**City of Seattle**  
Seattle Public Utilities

**TO:** Recipients of the Meadowbrook Pond Dredging and Improvements Project SEPA  
DNS/Checklist

**SUBJECT:** Addendum to the Meadowbrook Pond Dredging and Improvements Project SEPA  
Determination of Non-significance

Photo 1. Failed bank, looking upstream. The High Flow Bypass Inlet and Trash Rack are shown at right.

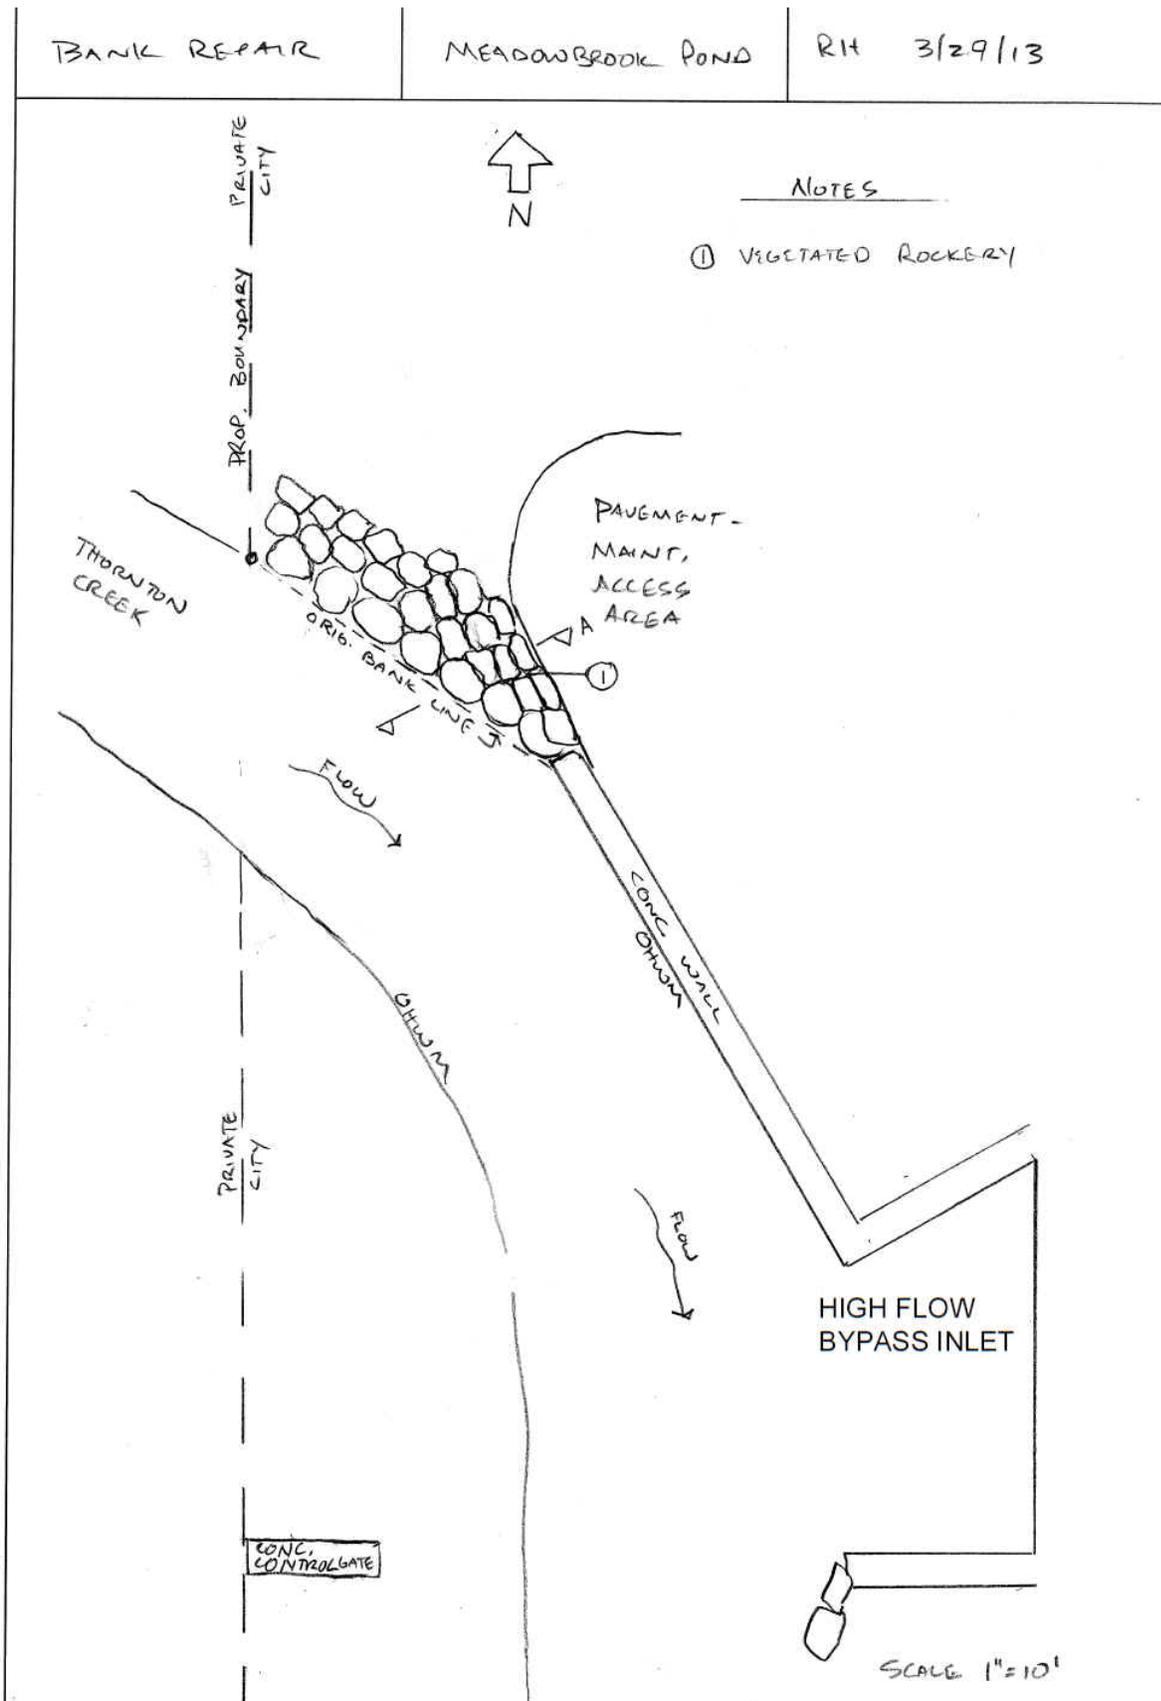
In February 2013, SPU staff discovered that approximately 15 linear feet of Thornton Creek stream bank had failed immediately upstream of the existing High Flow Bypass Inlet and Trash Rack at Meadowbrook Pond, sloughing 20 to 30 cubic yards of previously compacted soil and rock into the creek (Photo 1). Although the bank failure does not pose an apparent immediate threat to public safety or downstream property, the sloughed material should be removed and the bank restored to prevent further erosion during future storms. In addition, the bank must be restored in order to construct the SPU maintenance vehicle access improvements planned as part of the Meadowbrook Dredging and Improvements Project. Those improvements require a stable bank to accommodate the access road and vehicular traffic.

Figure 2. Plan view of proposed bank repair.

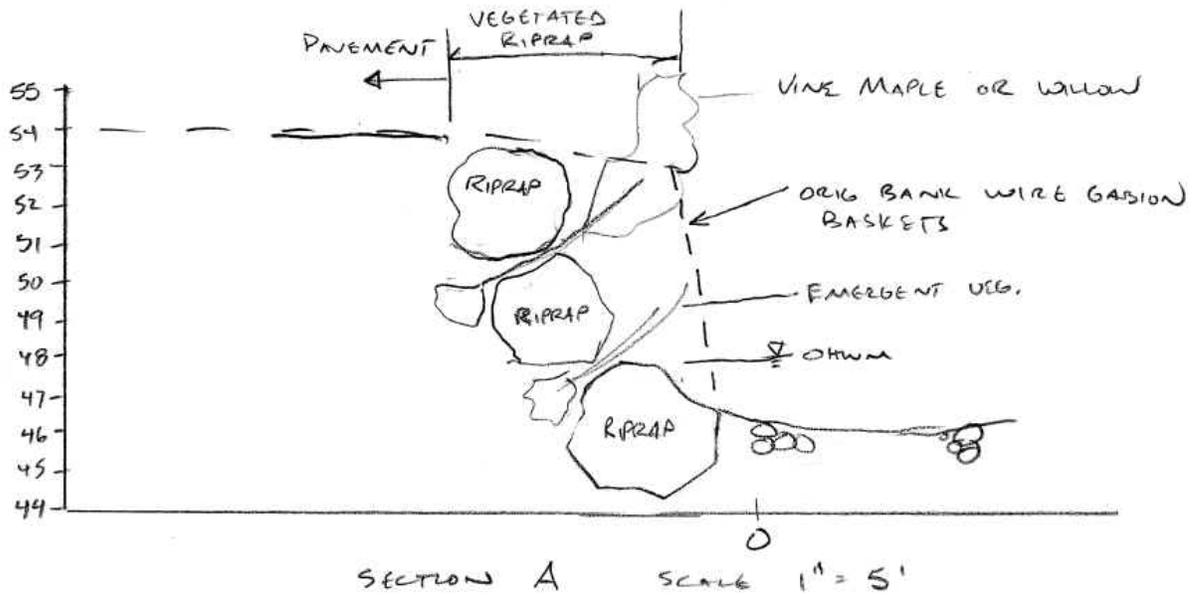
SPU has subsequently identified a bank repair (Figures 1, 2, and 3). This repair would require bypassing flow away from the affected reach of Thornton Creek for approximately 2 to 3 weeks. To minimize the number of Creek bypasses, SPU is proposing to conduct the bank repair at the same time (July and August 2013) that the affected reach of Thornton Creek is dewatered to construct some elements of the Meadowbrook Pond Dredging and Improvements Project. SPU would add the bank repair to the current scope of work of the contractor constructing that project.

The bank repair would use an excavator to remove approximately 20 to 30 cubic yards of sloughed soil and rock from Thornton Creek and the adjacent bank. The bank would then be rebuilt using 4-man (36 inch by 48 inch) rocks keyed 18 inches into the streambed. The top of these base rocks would be at the same elevation as the Ordinary High Water Mark (OHWM) of Thornton Creek in this reach. The next two layers would be comprised of 3-man (24 inch by 36 inch) rocks. Soil lifts (native soils mixed with compost) would be used between the rock layers and planted with a total of approximately 25 shrubs and approximately 25 vine maples or willows. Specific plant species to be used would be determined in the field during construction. All rocks and soil would be installed using an excavator.
